Cc: Kristen Outten; Amy Ow; robertpellegrine@yahoo.com
Subject: Re: Highland Estates Inspection Report 11/11/2020

Subject: Highland Estates Inspection Report 11/11/2020

**Subject:** Highland Estates Site Inspection 11/11/2020

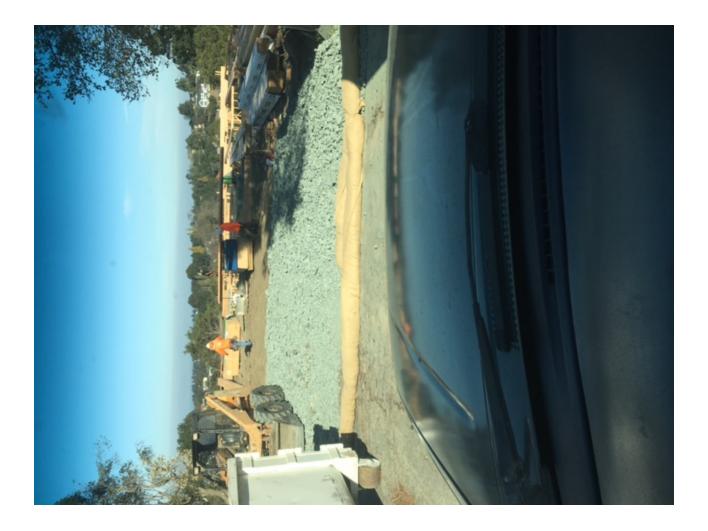
Bob just gave me a call and let me know that they have repaired the stabilized entrances at both Lot 9/10 and Lot 11. Bob sent me the attached photos confirming that this repair has been made.
